CLIO 2

Cancels and replaces Technical Note no. 809A dated July 2001
Modifications: replacement parts.

80B WATER IN THE FRONT FOG LIGHTS

Fig. 1

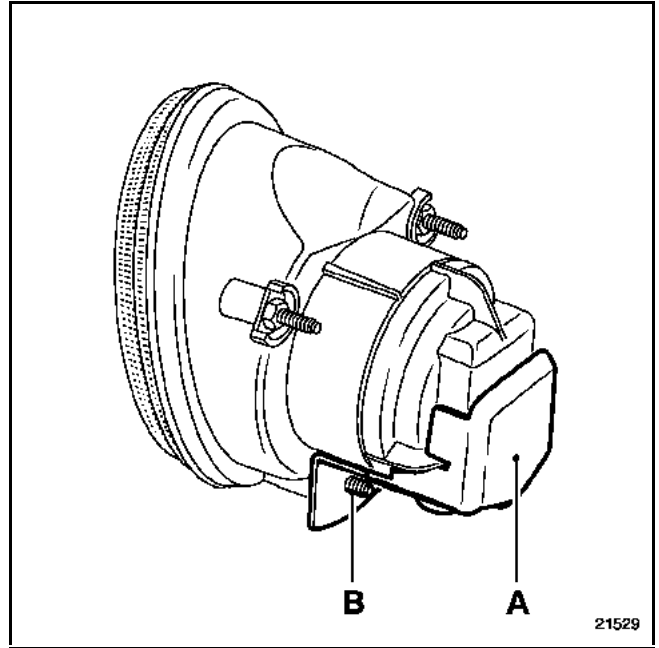
- Replace the fog light wiring.
- Fit two cover masks.

- 1 fog light wiring
- 2 fog light cover masks
905

- Put the vehicle on a two-post lift.
- Remove the front bumper.
- Replace the fog light wiring.
- Attach the fog light cover masks (A) (**Fig. 1**) using the fog light lower mounting bolt (B) (**Fig. 1**).
- Refit the front bumper.
- Adjust the fog lights.
